Access Compliance Report

Public Rights-of-Way

(Curb Ramps)

Intersection ID: 10032297	Main Street: MOUNTAIN_COVE_DR	Cross Street: N/A	Location: NE
ADA ID: DF576E5B05AE	Ramp Type: Perp	Initial Pass/Fail: Fail	Overall Compliance: No
Severity Score: 33.75			
Codes/Mitigation Info/Possible Solution		Field Measurements/Component Compliance

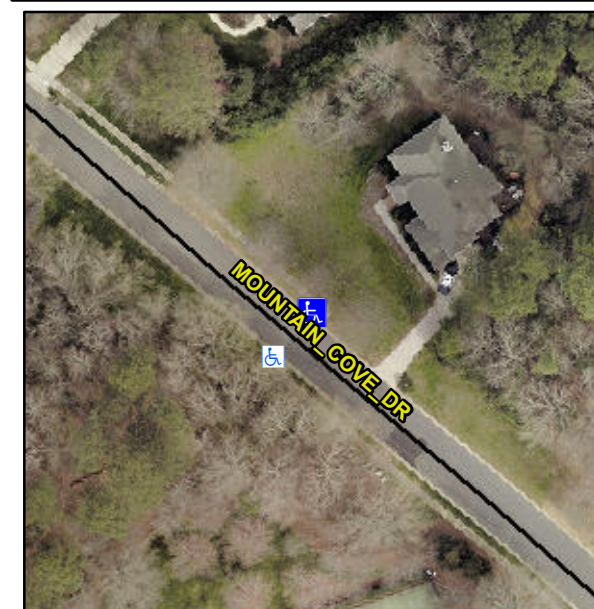
R304.5.1, R304.5.3

Compliance	Description	Data	Compliance	Description	Data
N/A	Ramp Length (in)	49.0	Yes	Ramp Slope (%)	6.8
No	Ramp Width (in)	47.0	No	Ramp XSlope (%)	12.2
N/A	Flare Type LT	N/A	N/A	Flare Type RT	N/A
N/A	Flare Slope LT (%)	N/A	N/A	Flare Slope RT (%)	N/A
N/A	Flare Traversable LT?	N/A	N/A	Flare Traversable RT?	N/A
N/A	Landing Length (in)	N/A	N/A	DWS Provided?	N/A
N/A	Landing Width (in)	N/A	N/A	DWS Contrast?	N/A
N/A	Landing Slope (%)	N/A	N/A	DWS Length (in)	N/A
N/A	Landing X Slope (%)	N/A	N/A	DWS Full Width?	N/A
N/A	Landing Curb? (Y/N)	N/A	N/A	DWS Offset (in)	N/A
N/A	Shared Landing?	N/A			
N/A	Gutter Ponding?	N/A	N/A	Gutter Slope (%)	N/A
N/A	Gutter Lip Ht (in)	N/A	N/A	Gutter X Slope (%)	N/A
N/A	Painted X Walk1?	No	N/A	Painted X Walk2?	N/A
	X Walk 1 Direction	To SW		X Walk 2 Direction	N/A
N/A	X Walk 1 Width (in)	N/A	N/A	X Walk 2 Width (in)	N/A
	X Walk 1 Slope (%)	4.5		X Walk 2 Slope (%)	N/A
	X Walk 1 X Slope (%)	8.7		X Walk 2 X Slope (%)	N/A

Remove & Replace Entire Ramp.
